Burnside Park Bathroom Building

ADDENDUM NO. 1

TO: All Bidders on the Above Referenced Product
FROM: Davis Purdy Architects, PLLC
DATE: March 26, 2026
SUBJECT: **ADDENDUM NO. 1**

1 FLOOR PLAN
1/2" = 1'-0"

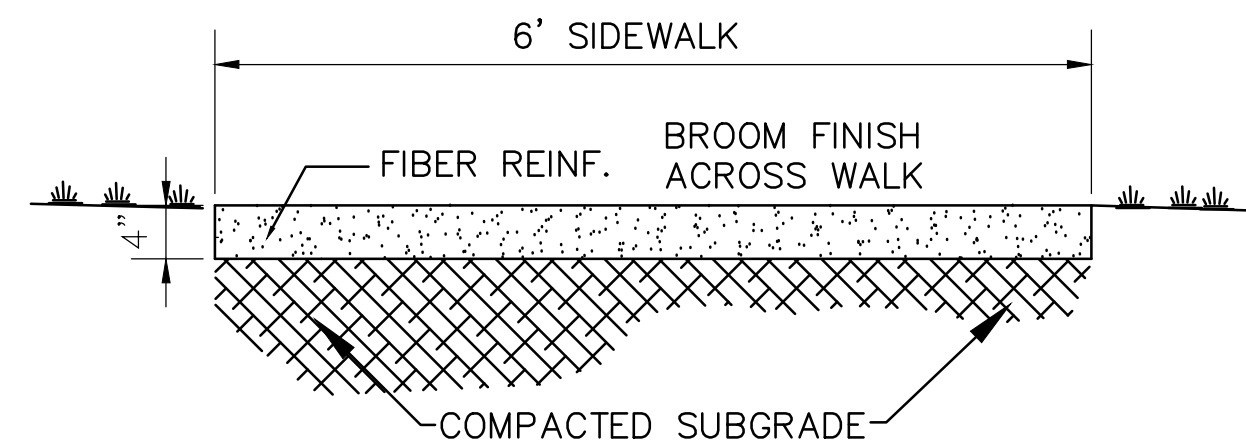
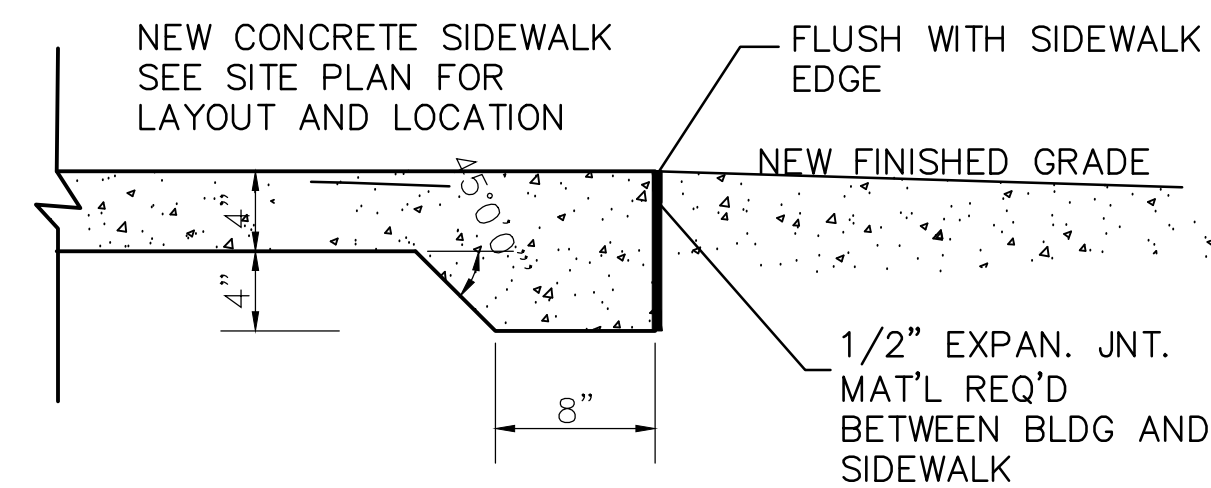
1. **ADD:** Add the **Pre-Bid Conference Meeting Minutes & Sign in Sheet**. Pre-Bid Conference Minutes are attached.
2. **ADD:** Specification section **00 60 01 – SUPPLEMENTAL CONDITIONS** dated 3/26/2026. Specification Section 00 60 01 is attached
3. **ADD:** Specification section **01 78 39 – PROJECT RECORD DOCUMENTS** dated 3/26/2026. Specification Section 01 78 39 is attached
4. **REPLACE:** Drawing **A101 FLOOR PLAN** dated 1/30/2026 with **A101 FLOOR PLAN** dated 3/26/26. Drawing A101 is attached
5. **REPLACE:** Drawing **C-600 SITE DETAILS** dated 1/30/2026 **C-600 SITE DETAILS** dated 3/26/26. Drawing C-600 is attached
6. **CLARIFICATION:** Contractor to use dimensions on the Architectural drawings in lieu of structural where discrepancies are found for the heavy timber columns. Contractor to 8” square columns shown in drawings.

- Timber Truss:
 - o Can it be built on site? **Yes**
 - o Douglas Fir? **Species to be Western Cedar in lieu of Douglas Fir, stained.**
- Discrepancies in column sizes and shapes between Arch and Structural drawings. **Columns to be 8" x8" Western Cedar to match the truss, stained**

7. **REPLACE:** Contractor to use Western Cedar for heavy timber trusses and column wood species in lieu of Douglas Fir
8. **CLARIFICATION:** All products & materials are required to be Build America, Buy America (BABA) approved.
9. **CLARIFICATION:** Electrical coordination study is required and will be the responsibility of the contractor to schedule and provide.
10. **REMOVE:** Remove the connection from the existing service to the transformer. Connection will be made by others. Selected contractor will need to coordinate the trenching of the roadway for placement of the fiber conduit with Central Electric to likely place the underground utility service.

C-600

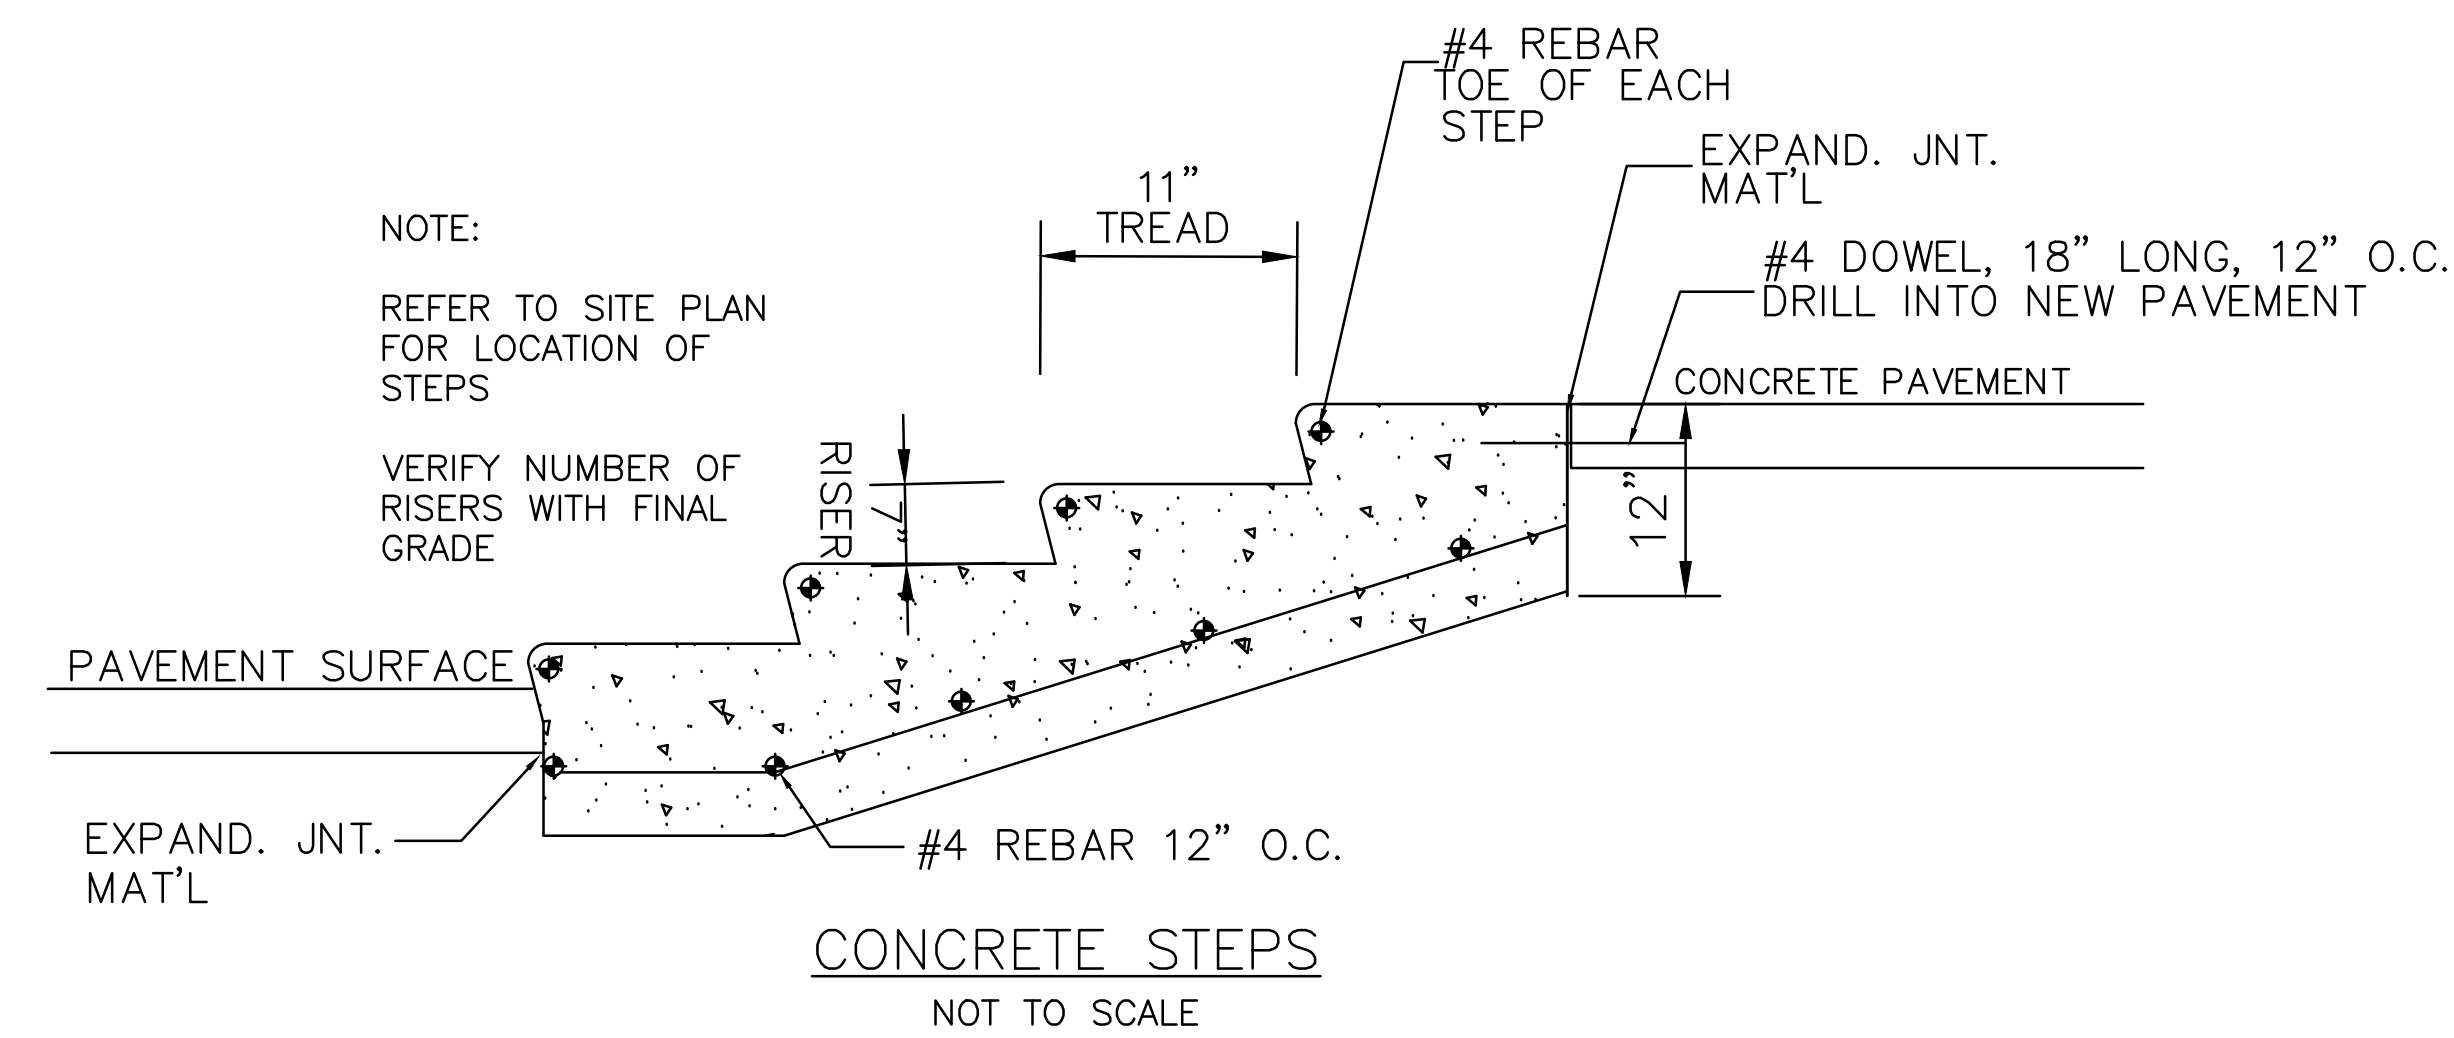
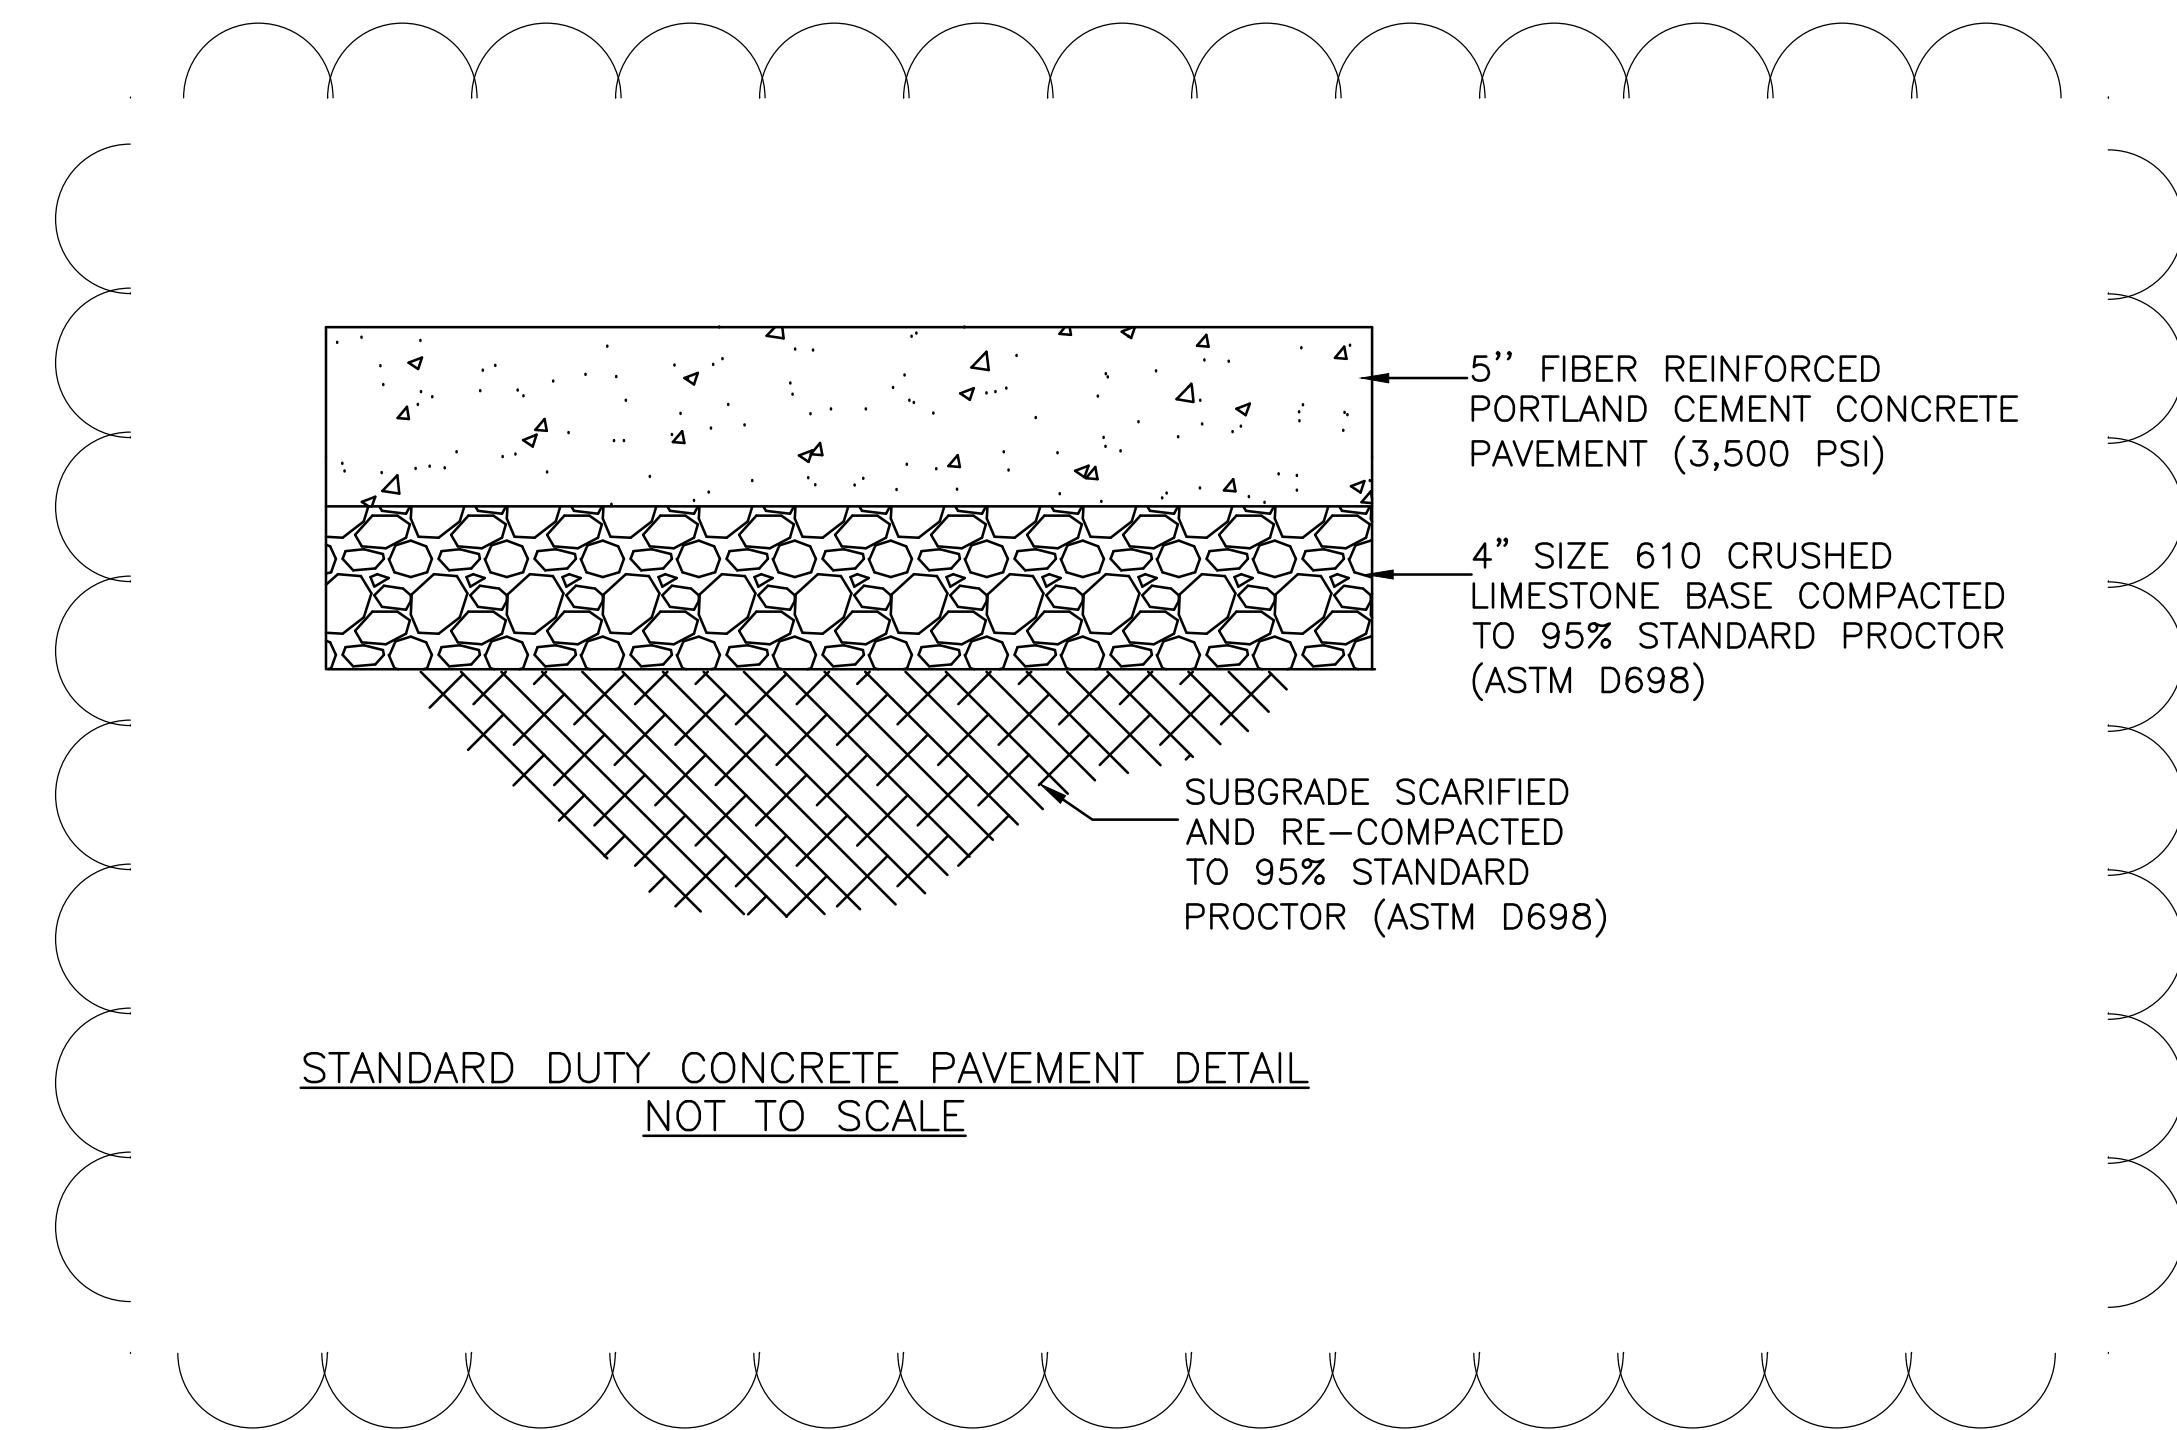
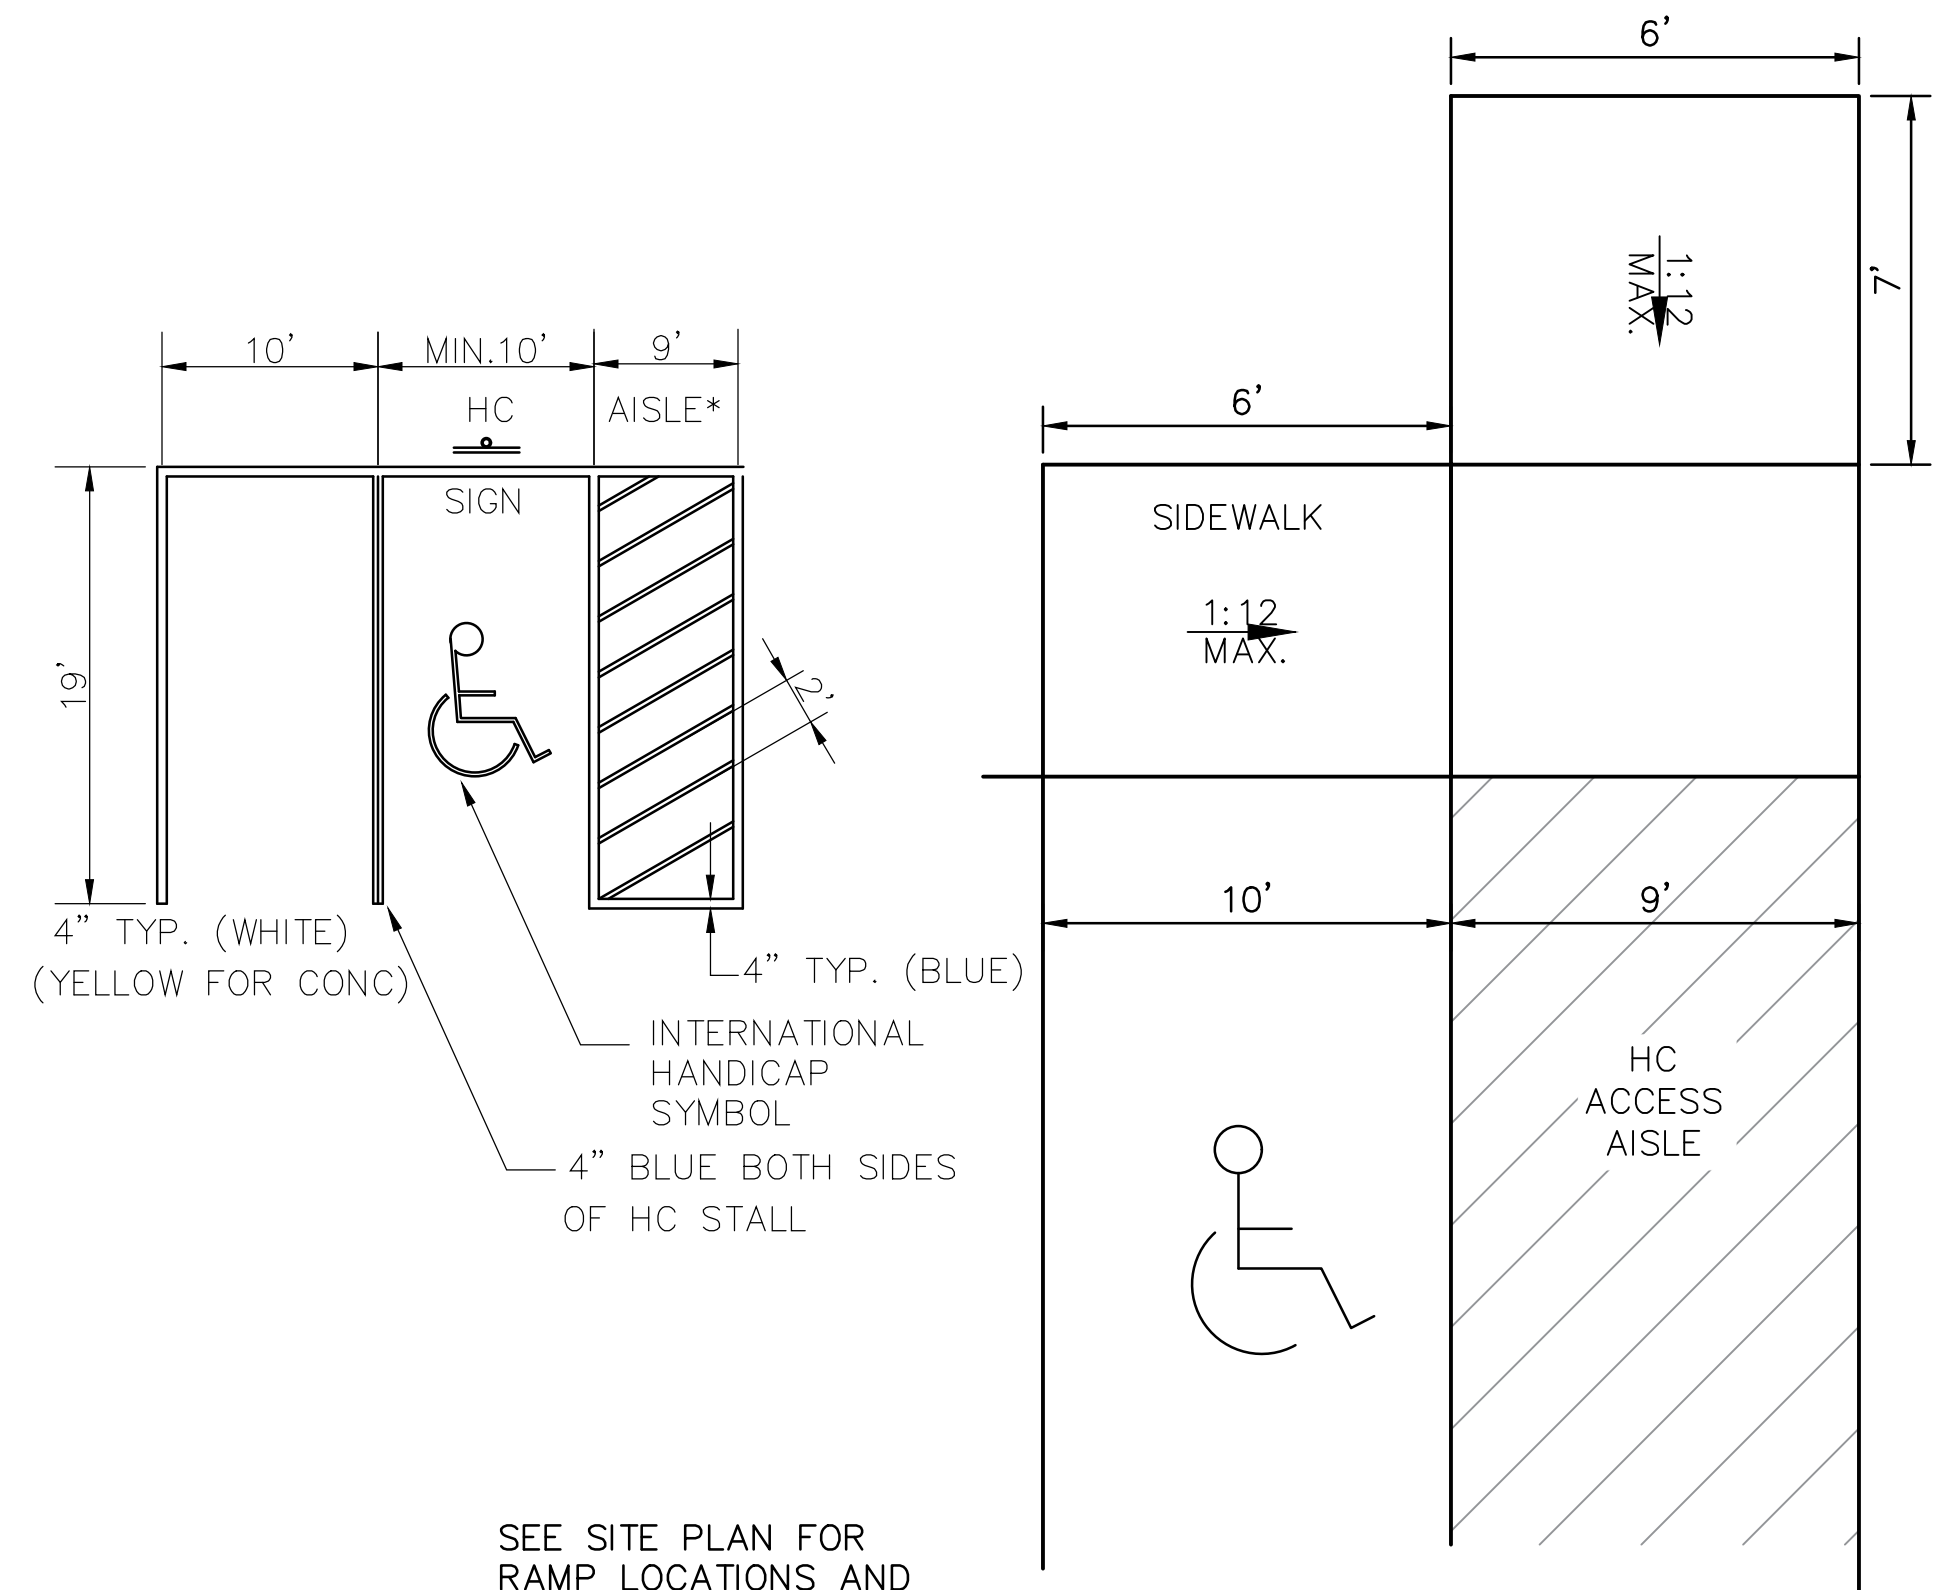
- Liquidated damages - **\$500 per day**
- Site concrete: wire or fiber? **Fiber**
- Parking area: concrete or asphalt? If concrete how thick? **Concrete, 5"**

- Curb detail requested – **no curb**
- Is the contractor required to provide a certified survey at the completion of the project per section 7300 - **No**
